File Number: D07-12-21-0180

Re: Site Plan Control Application

91 Holland Avenue

The following comments are provided in response to the first submission of the above application. Please review the items below, revise plans accordingly and provide a cover letter indicating how each of the comments has been addressed through the resubmission. ~~Please provide 3 sets of all revised plans as well as PDF copies of these plans.~~

Landscape Plan

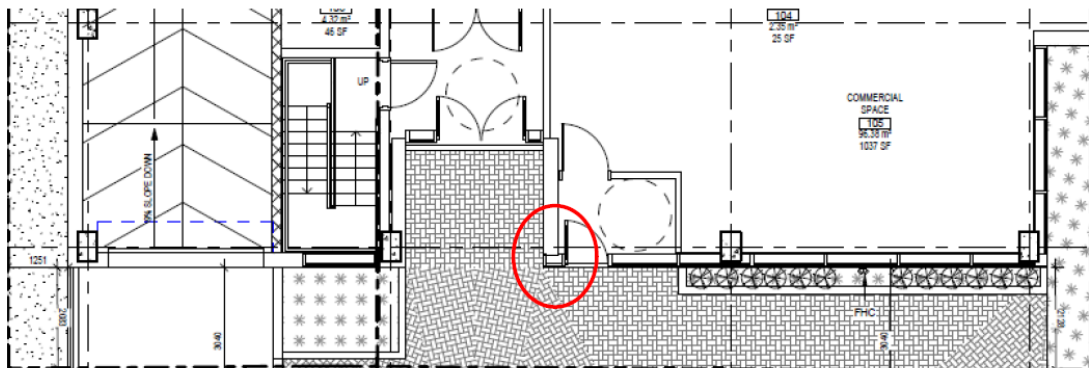
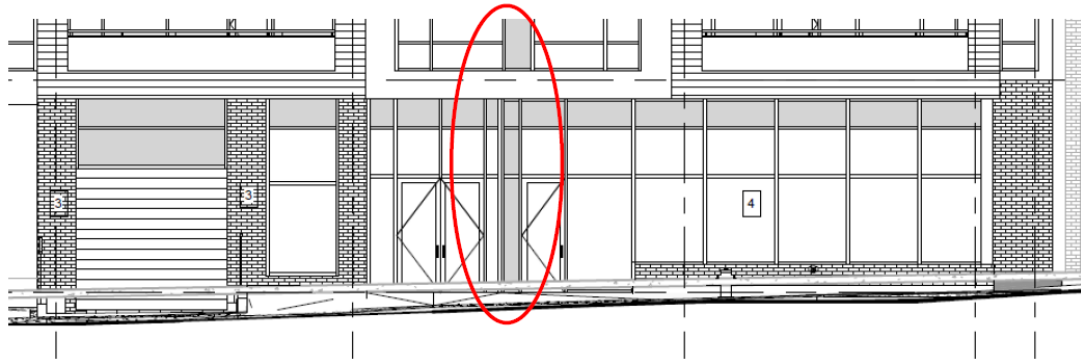
6. Please find ways to include more softscaping in the front yard. Perhaps a low planting bed next to the garage entrance. Please provide landscape plan with this.

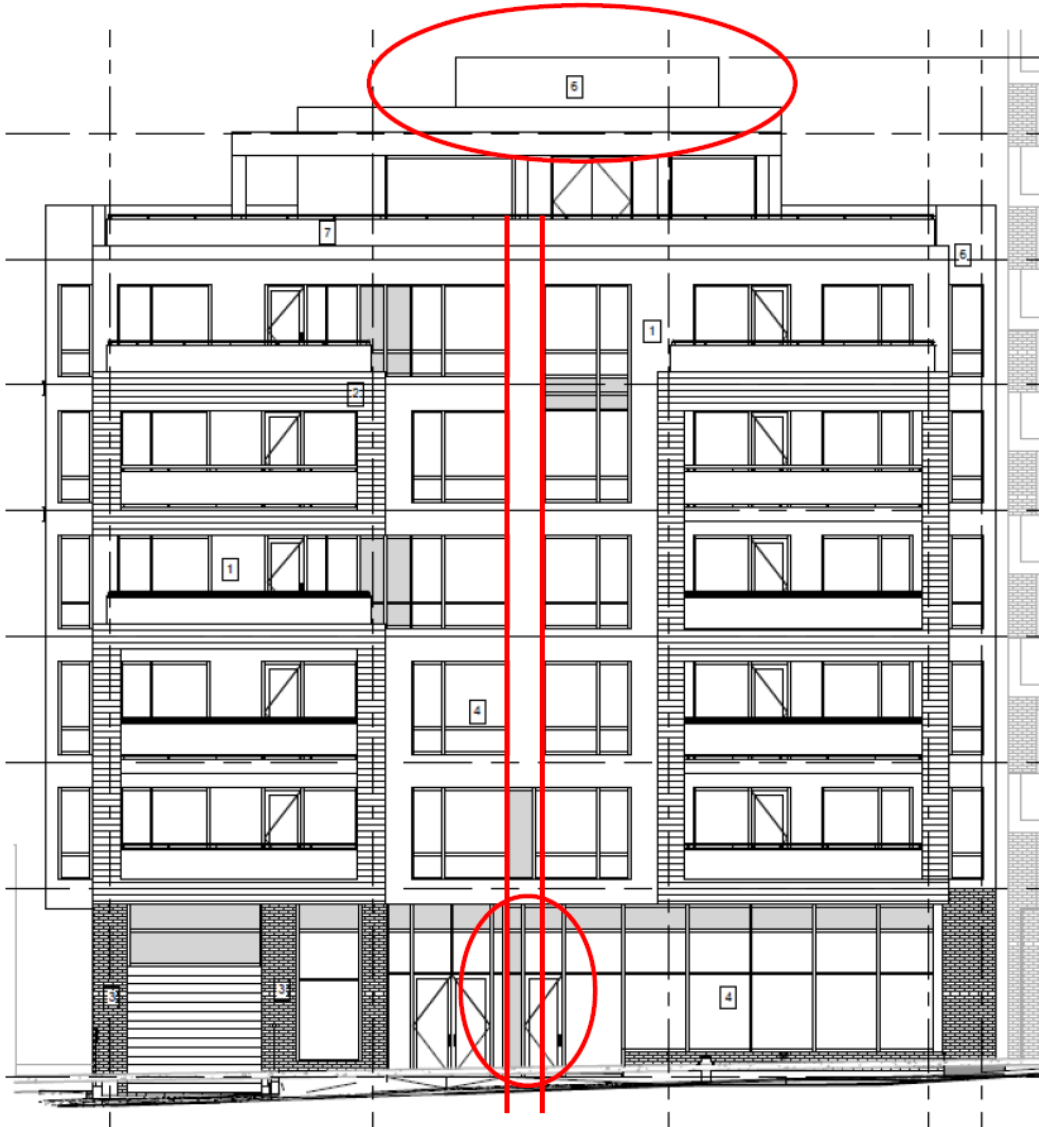
5. The narrow planters in front of the ground floor commercial space is not most conducive to retail/commercial uses.
6. Please study the area between the residential entrance and the commercial entrance in terms of façade treatment and materiality. For example, if a brick wall is to be installed between the residential entrance and the commercial unit, perhaps the wall should have a slightly wider return on the façade to create an alignment with the walls on the upper floors. If the idea is to present the commercial unit as a “glass box”, perhaps the brick wall between the residential entrance and the commercial entrance should be removed and replaced by a glass (see attached diagrams).
